# SYDNEY FOOTBALL STADIUM

RESPONSE TO SUBMISSIONS

LANDSCAPE AND PUBLIC DOMAIN

REV. 2

Appendix 2 - Ground Level - Soil Depths

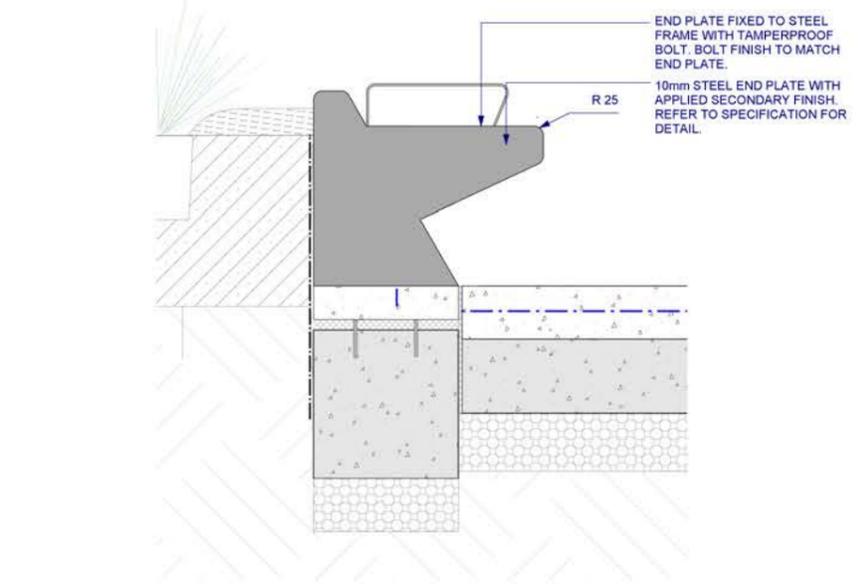
3.0 Insufficient Information 3.6 Landscape	Inadequate details were provided relating to soil depths, volume, drainage and irrigation of the proposed landscaping elements and trees proposed throughout the development. The landscape proposal fails to demonstrate the feasibility and maintenance of landscaping and longevity.	<p>Refer to Appendix 2 for a plan indicating site-wide soil depths. Strata cells has been specified for trees within the concourse hardscape, for detail refer to Planting Plans 18030_LA_401, 402, 403, 404 and Softworks Details 18030-LA-802.</p> <p>An allowance has been made for automatic irrigation systems to be installed in all planter beds. The water volumes of which will be tailored to the specific planting mixes and micro-climates in each location, with input from an irrigation designer, the detail of this will be refined in future stages.</p> <p>Proposed planting is predominantly (approximately 79%) native and endemic species. Where exotic species have been chosen hardy species have been selected. This forms hardy and robust planting palette which is truly suited to the SFS site and will require less maintenance.</p>

Appendix 1 - Wall Type 1 Detail

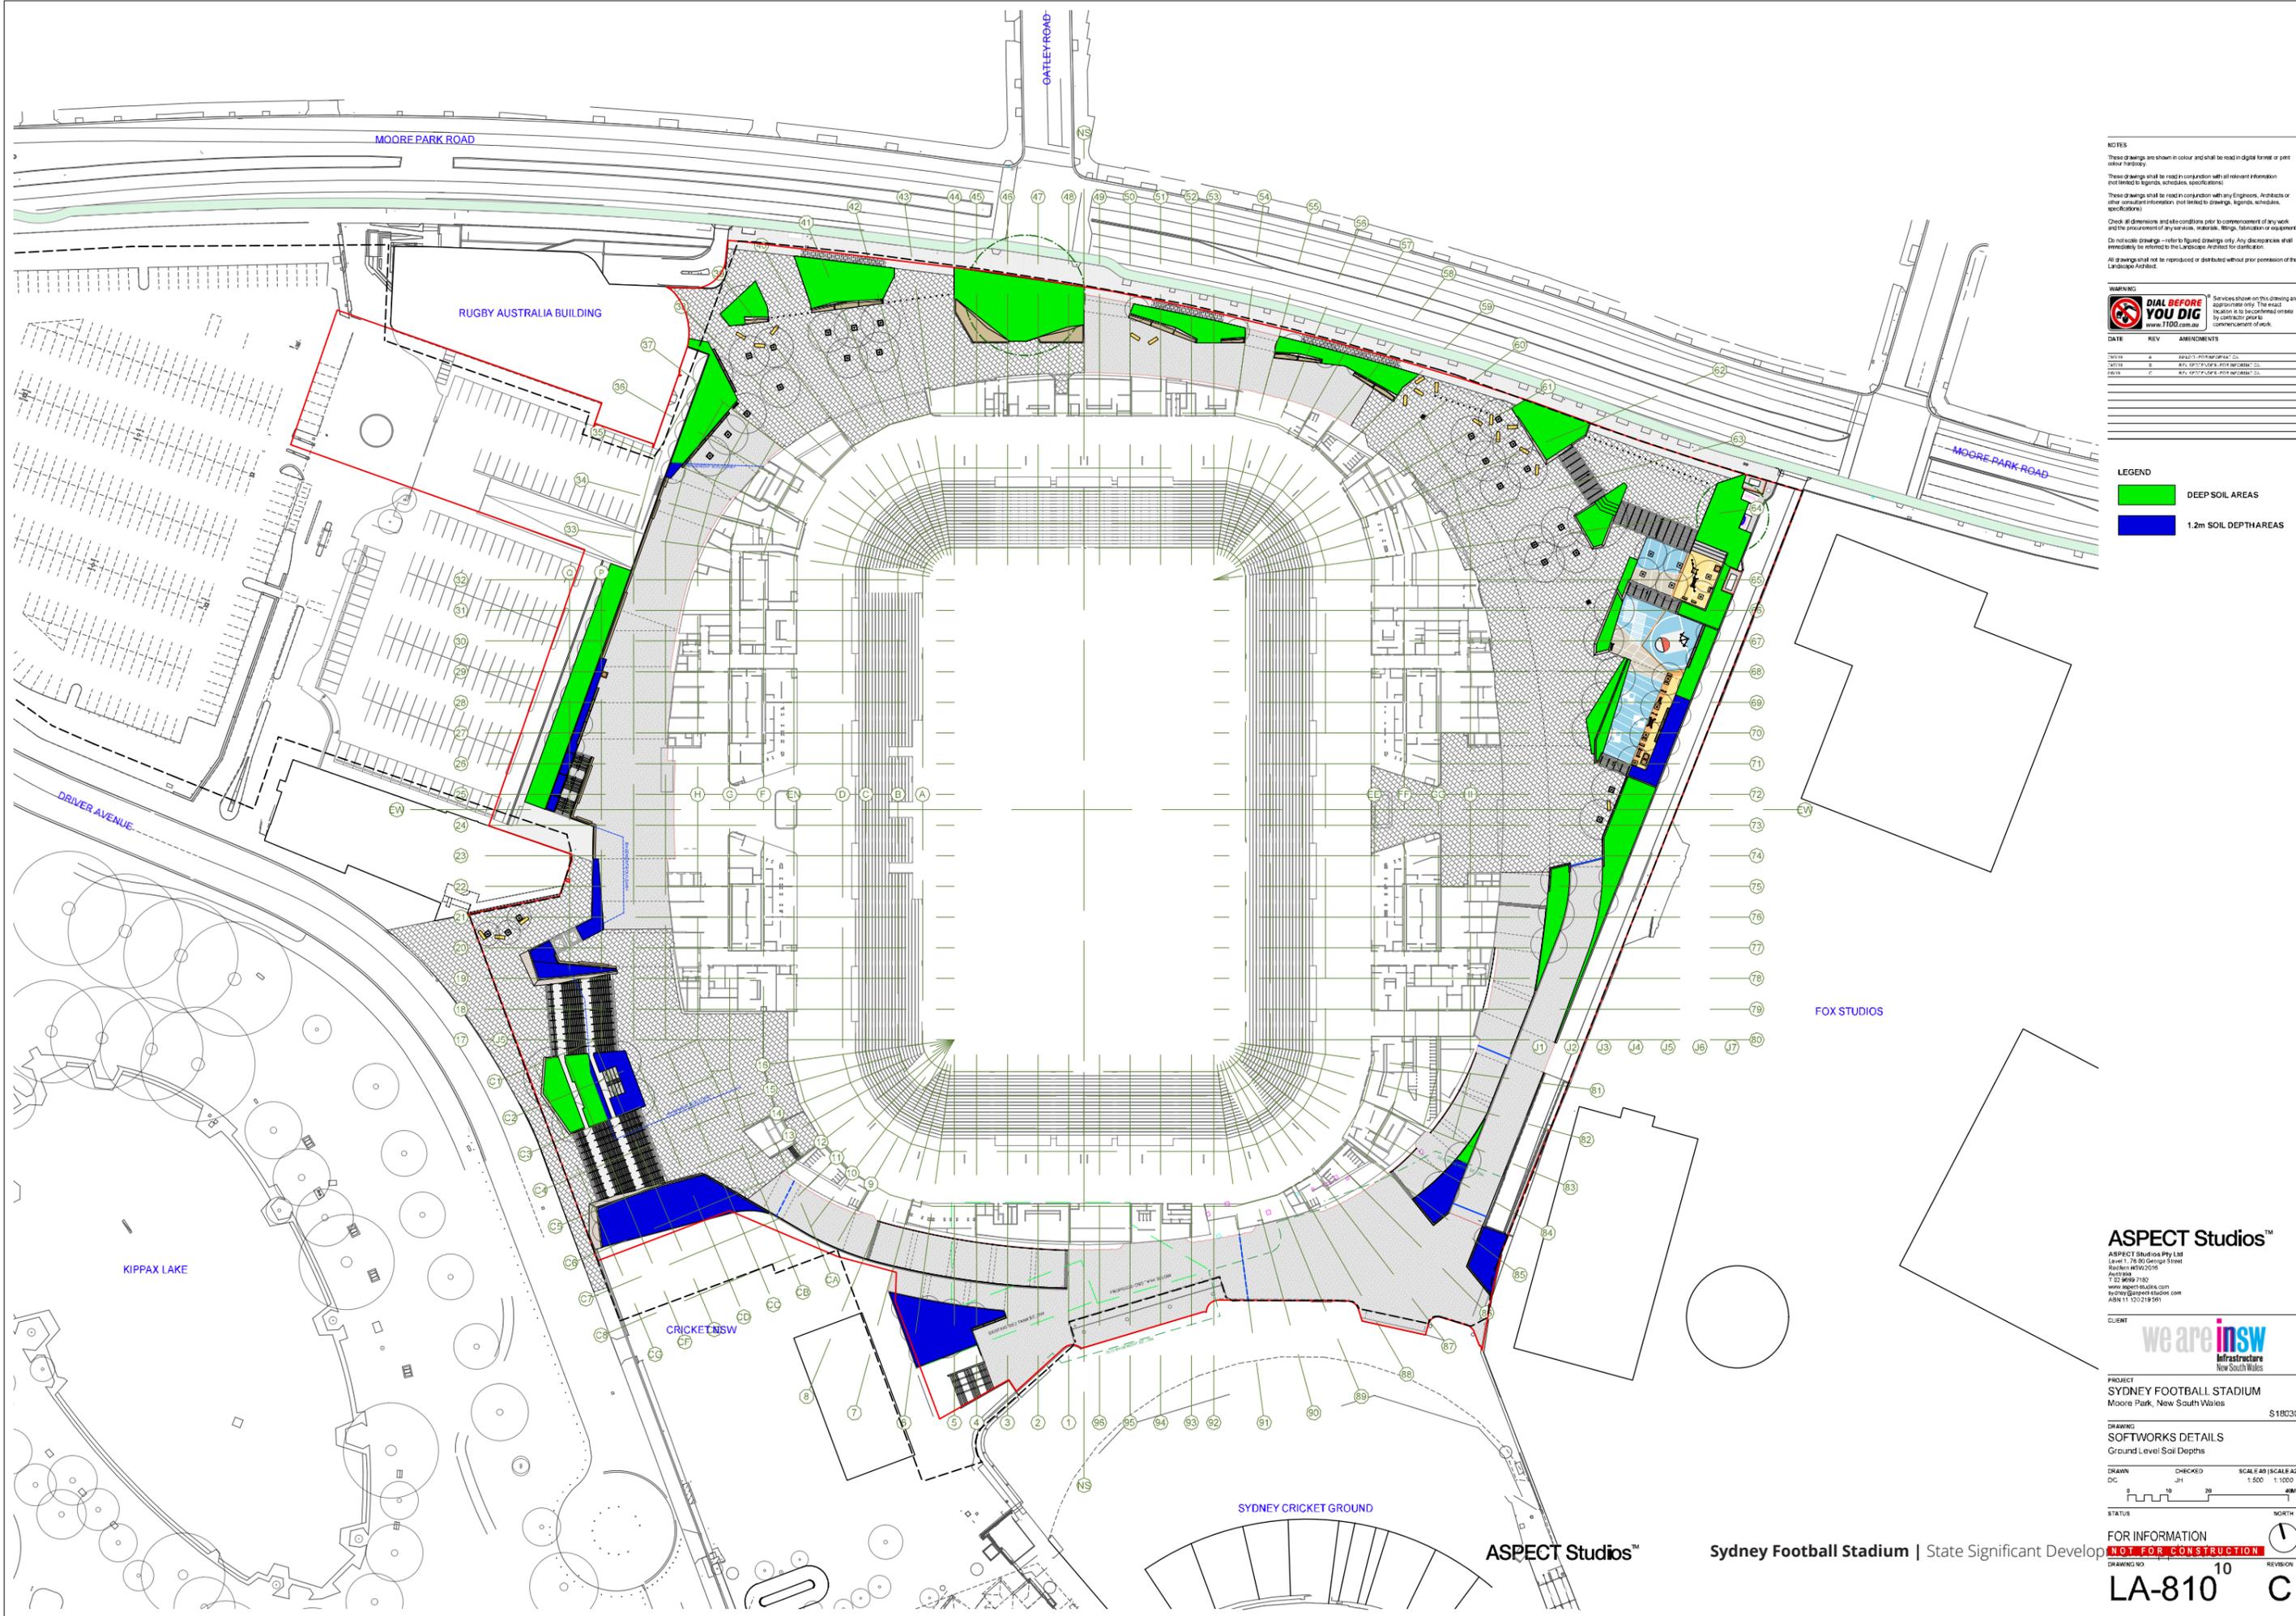
Item	Objection	Response	Public Domain Reference
1.1.2 Public Domain Materials	<p>Ensure that some integrated seating include back and arm rests to make seating more inclusive for the elderly.,</p> <p>Provide regularly recessed areas in integrated seating to enable wheelchair users and families with prams to sit together;</p>	<p>ASPECT Studios have reviewed the Draft policy and guidelines for inclusive and accessible public spaces and events and note that in principle the public domain design adheres to these guidelines and requirements and has been designed in accordance with Australian Standards, The BCA and Green Guide. The SFS Public Domain works are entirely located within the project site boundary but are inherently connected back to the CoS public spaces of Moore Park Road and Driver Ave. Providing clear and accessible connections between the site and adjoining public domain have been a key focus of this project.</p> <p>The public domain design has focused specifically on creating a public concourse that is entirely accessible – achieved via max 1:20 walkways. In some areas 1:14 ramps have been utilised; however these are located away from zones with consistently large pedestrian volumes.</p> <p>To achieve an accessible concourse with flush entries into the stadium, the concourse has been raised to the Moore Park Road Level affording predominantly flush connections in to the site for the majority of the northern boundary (which is currently inaccessible). Stair access has been introduced at the Driver Ave connection at the pinch point between the existing NRL building and cricket practice wickets. Two public lifts are located in this area to provide access to the concourse (a ramp in this location would exceed the BCA requirements for ramp rise).</p> <p>While considered in the current landscape works, further detailed design of furniture, kick rails, shorelines, artwork integration and signage will be refined in future stages of the project and will be designed to comply with these policies and guidelines.</p> <p>Specifically, ASPECT Studios will update Wall Type 1 to include backrests to provide additional integrated seating. Note, Armrest are already provided.</p> <p>Spaces have been designed to be inclusive and to consider wheelchair users and families with prams. See examples provided.</p> <p>It is anticipated that a final Landscape Plan, prepared prior to construction commencing, will detail the furniture design.</p>	 <p>Wall Type 1 Detail - Refer to Appendix 1.</p>
